Nature of Work: REMOVE OLD ROOF & REROOF W/PIONEER TILE 4/12 PITCH - SFR - 34SQS

TILE ROOF WORKSHEET

Subject: Structural Investigation Report of the Roof for the Residence located at 6460 Harmon Drive, Sacramento, CA 95831.

1 ROOF PLAN - GYSTER
 N.T.S.

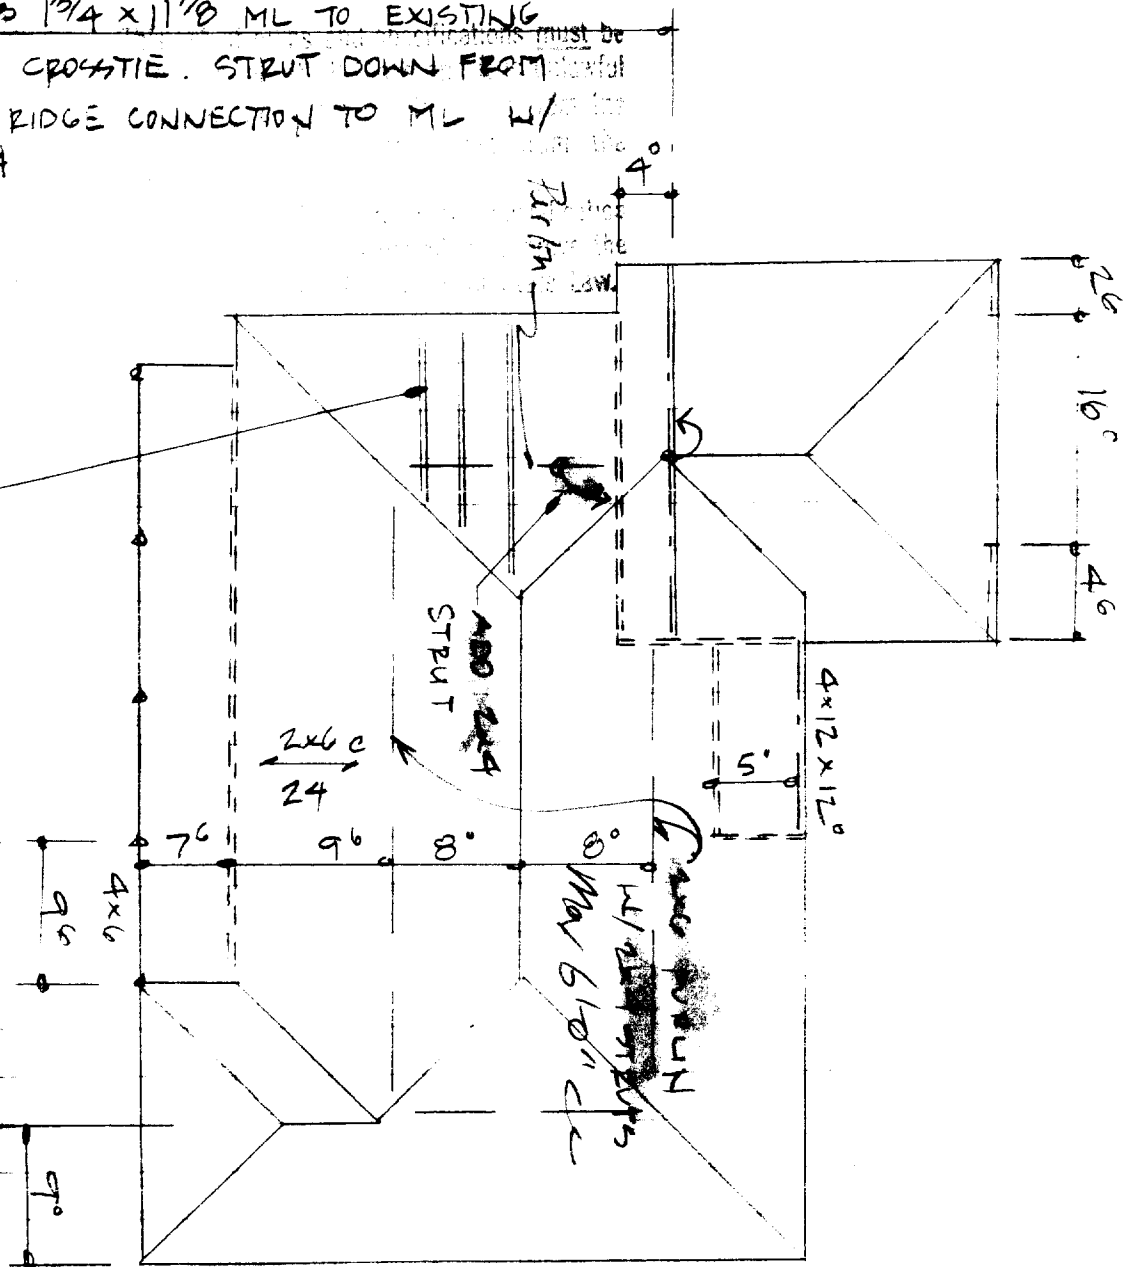
SLATS 1 3/4" x 1 7/8" ML TO EXISTING
 2x6 CROSS-TIE. STRUT DOWN FROM
 HIP/RIDGE CONNECTION TO ML W/
 2x4

SCANS EXT TO EXISTING 2x6 WHERE
 SPAN EXCEEDS 12' (TOTAL 3)

Notes added based on
 engineering report.
 May 2016 re: span.

Reviewed by M.P.P.
 11/25/98

1. Provide an additional 2x4 strut from the existing purlins to the bearing wall below. The minimum slope of the struts shall not be less than 45 degrees from the horizontal. See detail 1.

2. Scab a 1 3/4" x 11 7/8" microlam beam to the existing 2x6 crosstie and nail together with 16d's @ 12" oc. The ends of the microlam may be clipped as required to meet the slope of the rafters. Support the existing hip/ ridge connection to the microlam beam with 2x4 struts. See detail 1.
3. Scab 2x6 rafters to the existing 2x6 rafters with 16d's @ 12" on center where the span is greater than 12'-3" (total 3). See detail 1.
